SERVICE BULLETIN

M-949

XLH TRANSMISSION CAM FOLLOWER

Figure 1. Early and Late Cam Followers

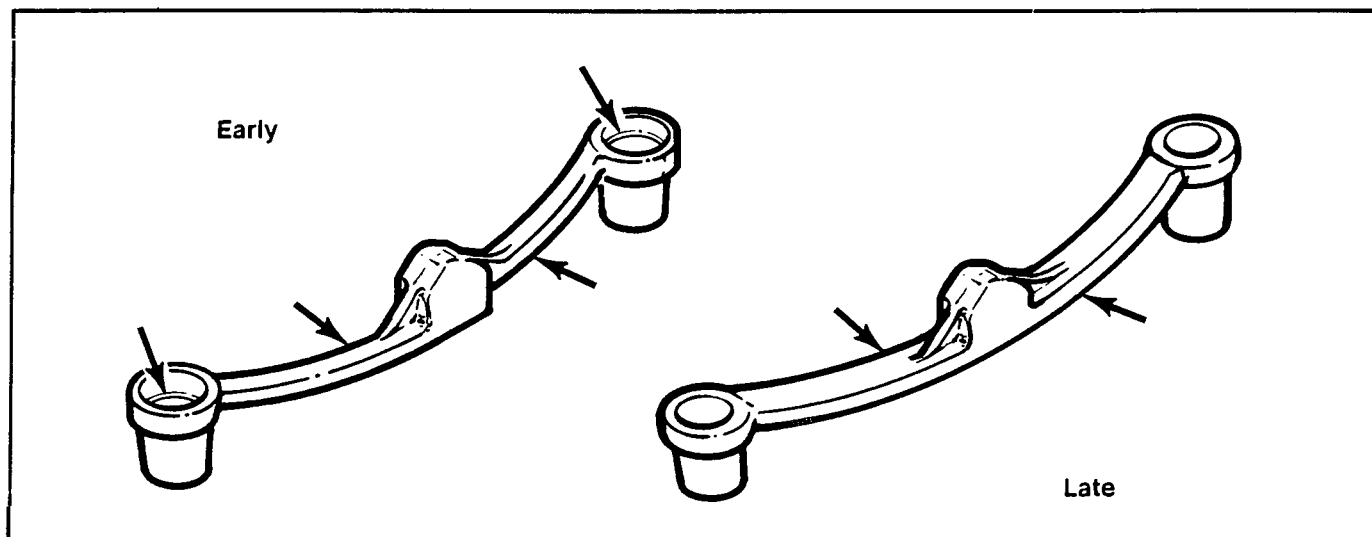
Early and late style cam followers are identified as follows, see figure 1;

Late style, Part No. 34063-84A.

1. Holes in cam followers are not counterbored.
2. Cam follower arms are not offset.
3. the cam follower is not magnetic.

Early style, Part No. 34063-84.

1. Holes in cam follower are counterbored.
2. Cam follower arms are offset.
3. the cam follower is magnetic.

Vehicles experiencing this problem should have the cam follower replaced with the early style, Part No. 34063-84. Instructions for replacing the cam follower can be found in the 1986-87 XLH Service Manual, Section 6.
